**CENTER FOR DRUG EVALUATION AND
RESEARCH**

215352Orig1s000

PRODUCT QUALITY REVIEW(S)

SUBJECT: NDA 215352 (ICC2200986), Engineering Review
Eyenovia Inc.

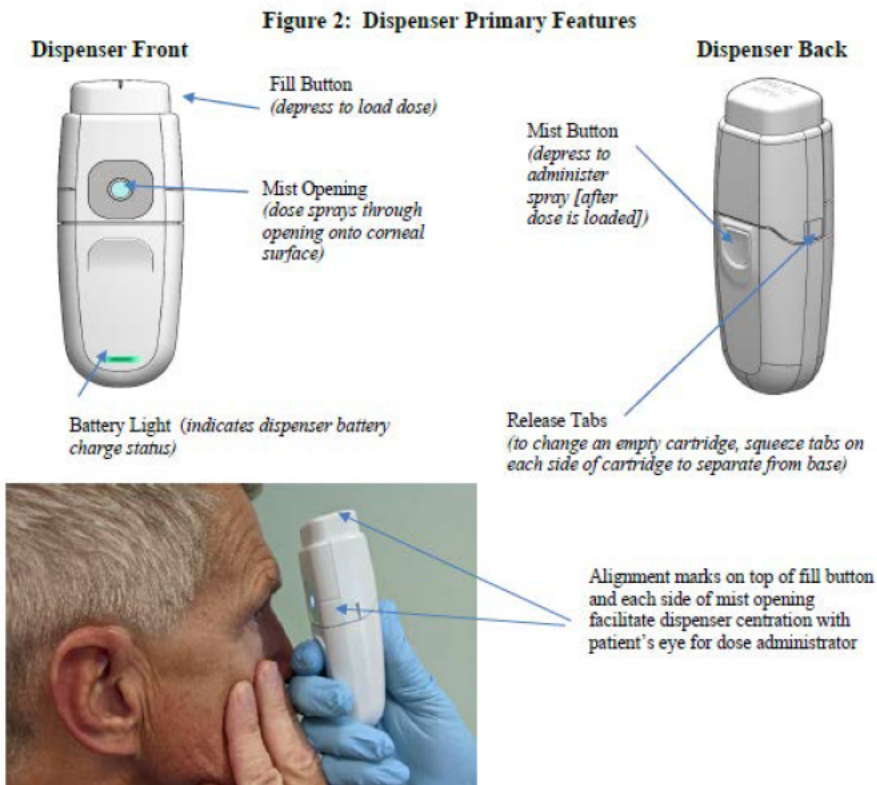
Engineering Reviewer Comment: The sponsor has not provided justification for the force limits. A request will be made for them to provide justification. **INFORMATION NEEDED**

Engineering Reviewer Comment: The sponsor has not provided justification for the force limits. A request will be made for them to provide justification. **INFORMATION NEEDED**

Engineering Reviewer Comment: The sponsor has not provided justification for the force limits. A request will be made for them to provide justification. **INFORMATION NEEDED**

*The sponsor has cited ANSI standards for human factors engineering design of medical devices (ANSI HE75). The sponsor has adequately cited the force testing conditions that are discussed in the standard. Although the ANSI standard is only partially recognized by the FDA. However, this partial recognition does not impact the acceptability of the limits. Additionally, the file also had additional human factors reviewers from CDER, who also did not have issues with the limits in their review. Therefore, the justification is adequate from an engineering perspective and the concerns with the testing limits have been resolved. **RESOLVED***

FIGURE 1: EYENOVIA MiDD FRONT (L) AND BACK (R) VIEW

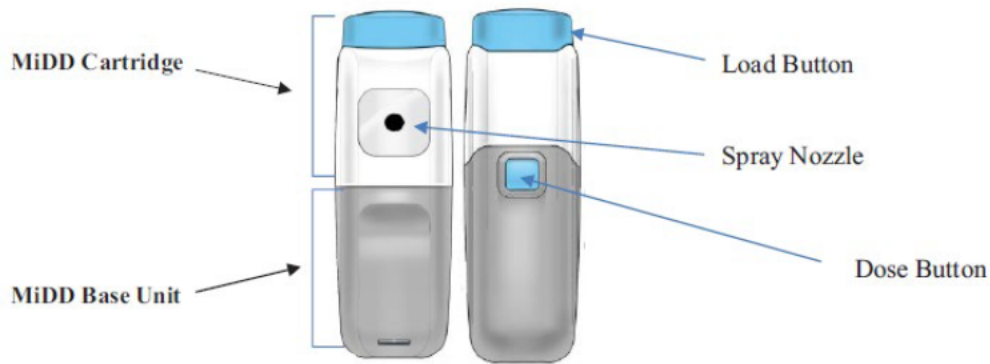
Engineering Reviewer Comment: The sponsor states that the dose volume is controlled by physical/chemical properties of the drug formulation, which I am assuming is dependent on the (b) (4)

Sponsor may be requested to clarify the electrical component. (b) (4)

(b) (4) Please clarify the electrical component of your device.

2. In your submission (p. 13), you have stated that the device i (b) (4)
Please clarify the reusability of the device in order to determine if additional testing is needed.
